Re: Martinez Retail/ PHASE 1
1021 Old Coors Dr. SW
Traffic Circulation Layout
Architect's Stamp 04-22-24 (L11-D071)

The TCL submittal received 02-01-2024 is approved for Building Permit by Transportation. A copy of the stamped and signed plan will be needed for each of the building permit plans. Please keep the original to be used for certification of the site for final C.O. for Transportation.

TRAFFIC CIRCULATION
LAYOUT APPROVED

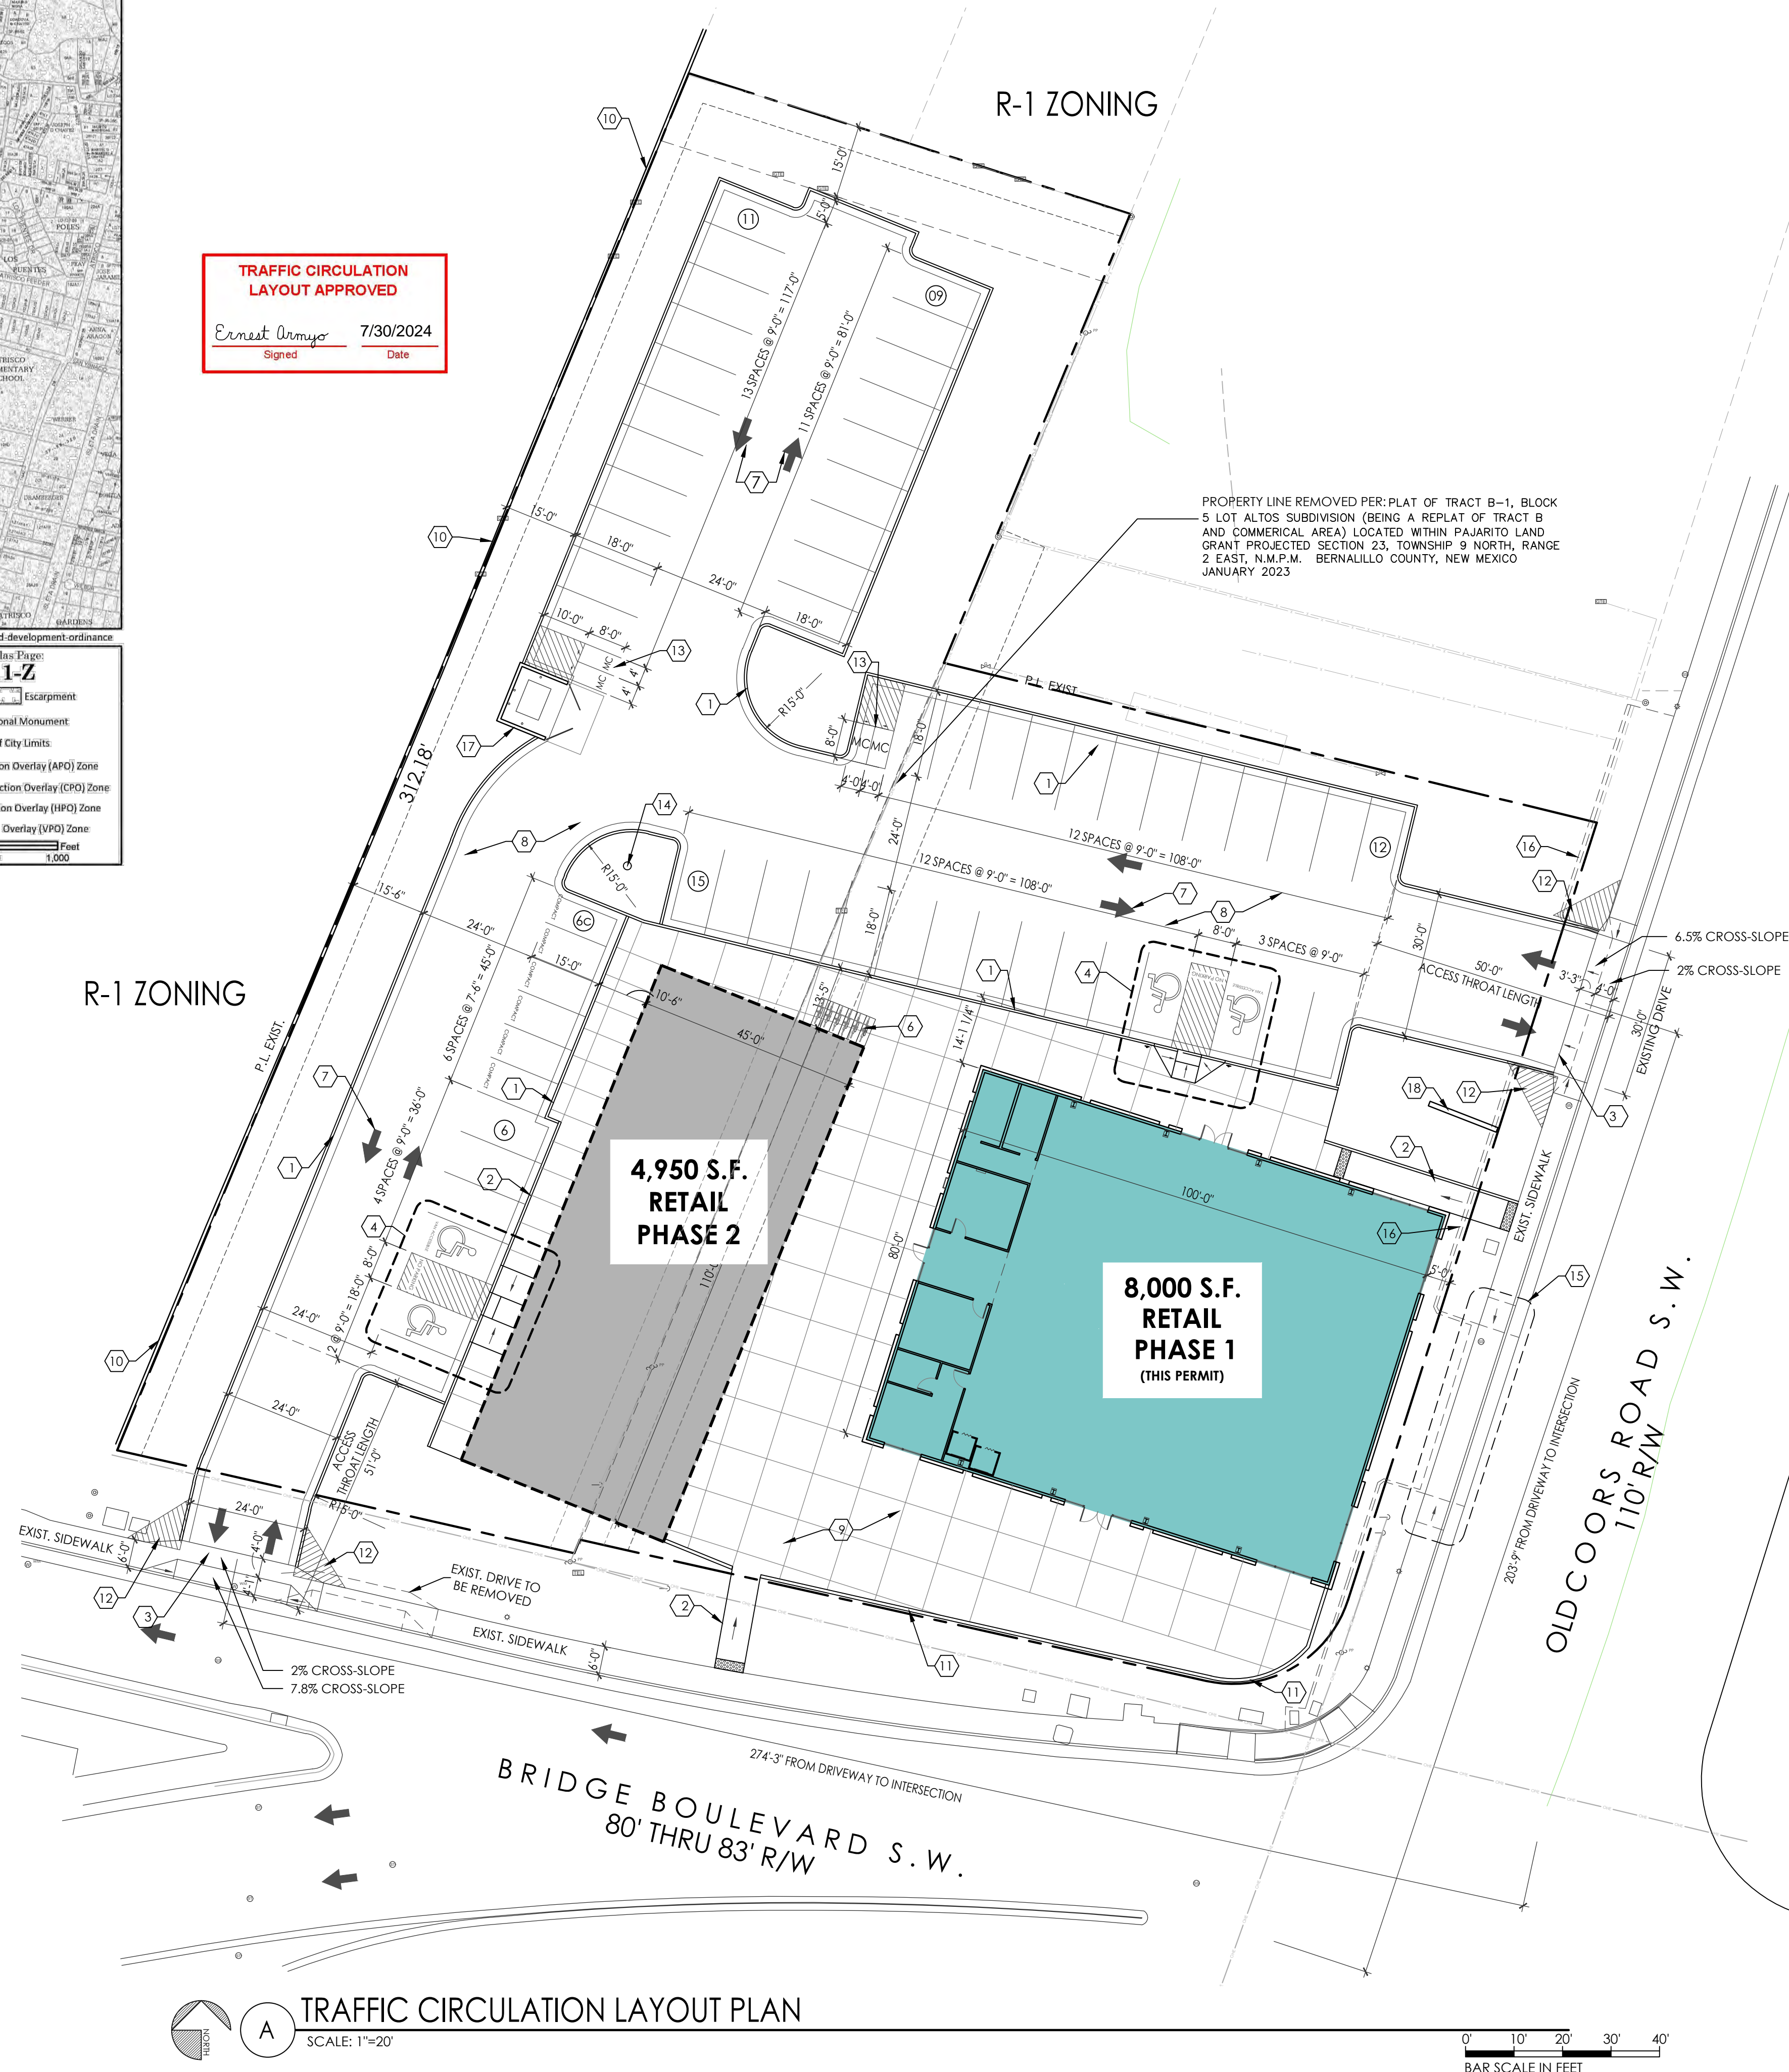
AN APPROVED PLAT IS A CONDITION OF RELEASING THE FINAL CO FOR PHASE 1.
